ADDENDUM NO. 03

To Drawings and Specifications dated September 10, 2026.

TOMBALL HIGH SCHOOL ATHLETIC IMPROVEMENTS

Tomball Independent School District

1 **MECHANICAL ROOF PLAN - RESTROOM A101**
SCALE: 1/2" = 1'-0"

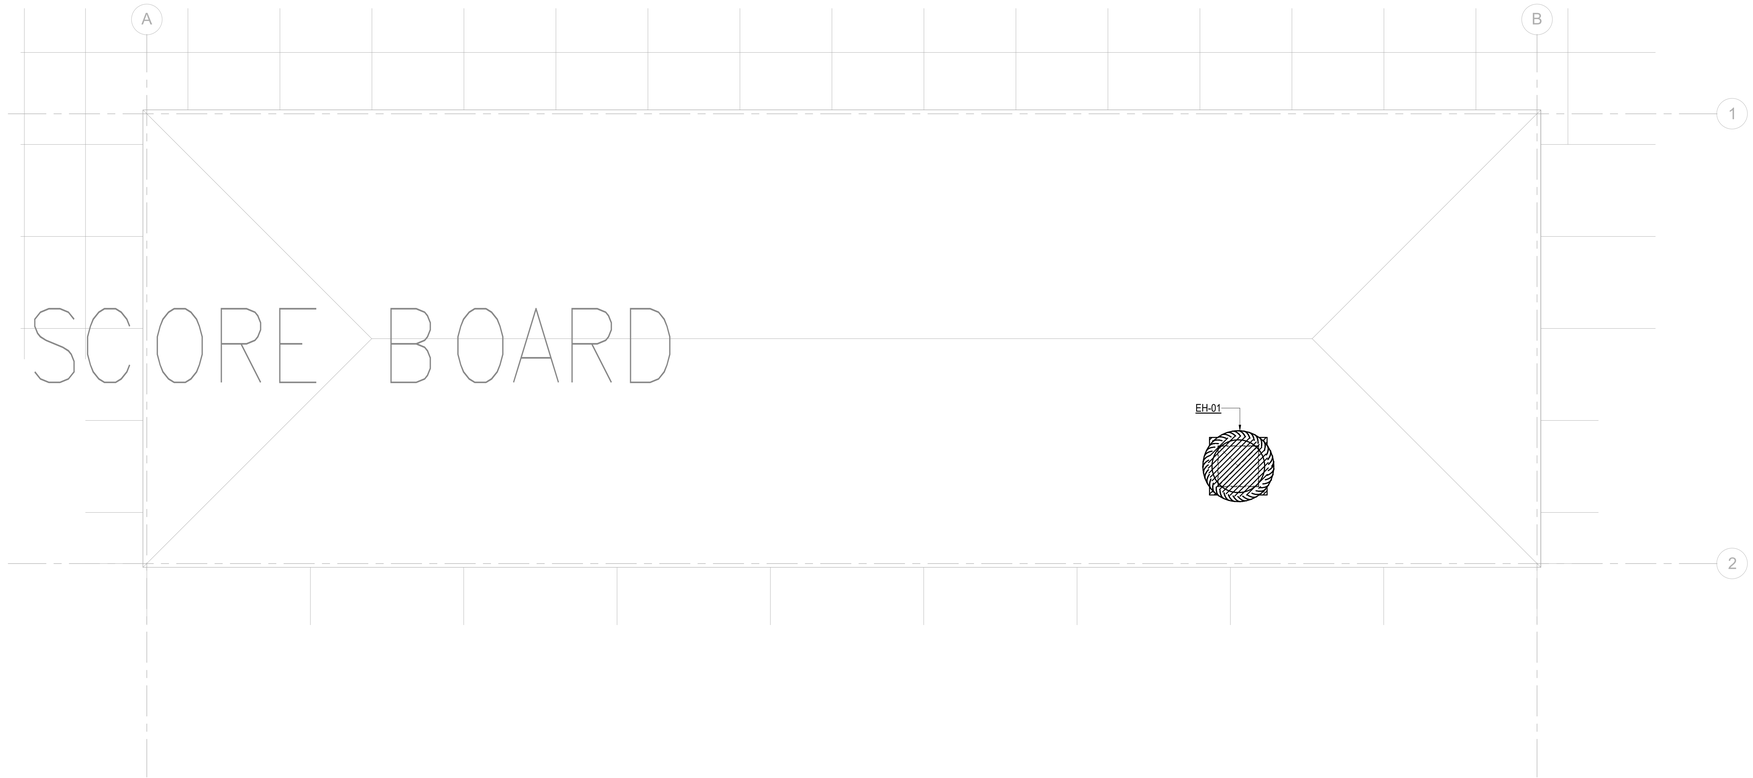
Item No. 24 **M-201 Mechanical Roof Plan – Restroom A101**
Add sheet in its entirety.
